改訂A 2023年 9月 吉日

## 製品仕様変更のご案内

| 1 | 対象製品   | 単相及び三相トランス  |

Name	旧端子 „Adels RKW14“	新端子 „Conta Clip TKS4“
<b>Dimensions</b>

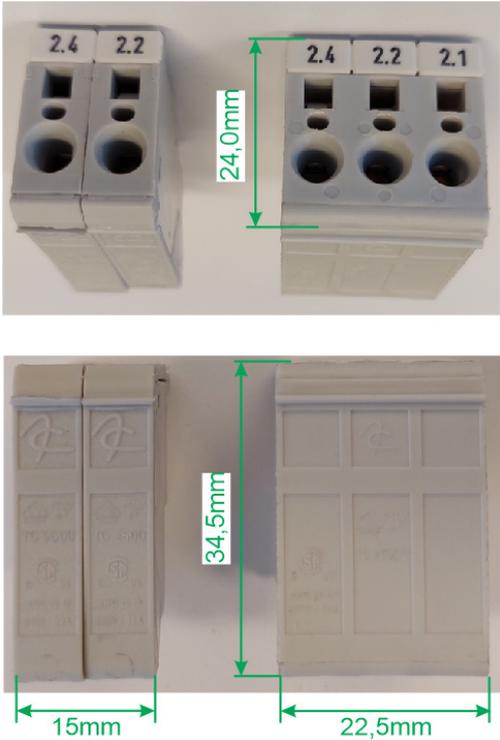
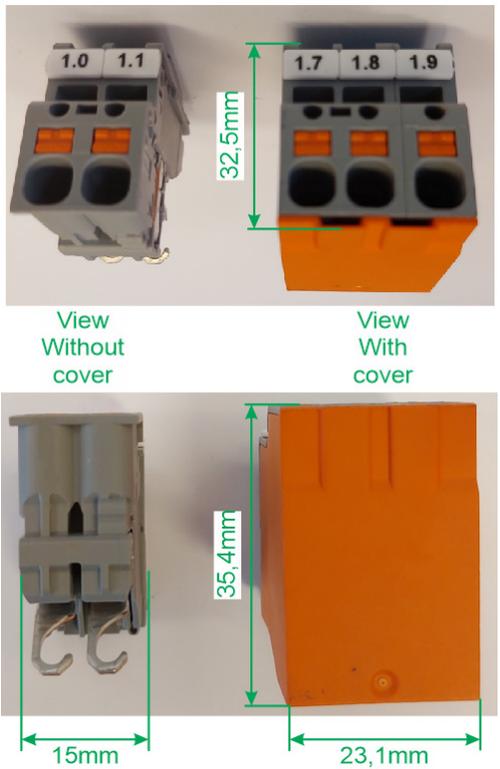
| 3 | 変更内容   | 端子台がAdels社のものより、Conta-Clips社のものに変更となります。<br>製造者 <u>Adels</u> → <u>Conta-Clip</u><br>型式 RKW14 → TKS4 ネジ端子<br>RKW110 → TKS10 ネジ端子<br>TC2500 → PTKS4 スプリング端子 (GMTTで使用)<br>仕様詳細は添付の比較表を参照下さい。   |

<b>Technical Properties</b>		
Type of terminal	Screw connection	Screw connection
Color	Grey	Dark grey
Rated Voltage	IEC: 750V <sup>1)</sup> UL: 600 V	IEC: 800V <sup>1)</sup> UL: 600 V
Rated Current	20 A	20 A
American Wire Gauge	20-12	22-10
Cross- section	0,5 - 4 mm <sup>2</sup>	0,2 - 4 mm <sup>2</sup>
Screwdriver	SDB 0,8x4,0	SDB 0,8x4,0
Maximum torque	0,6 - 0,8 Nm	0,5 – 1,0 Nm
REACH conformity	Yes	Yes
ROHS conformity	Yes	Yes
Other conformities	IEC, UL, CSA	IEC, UL, CSA
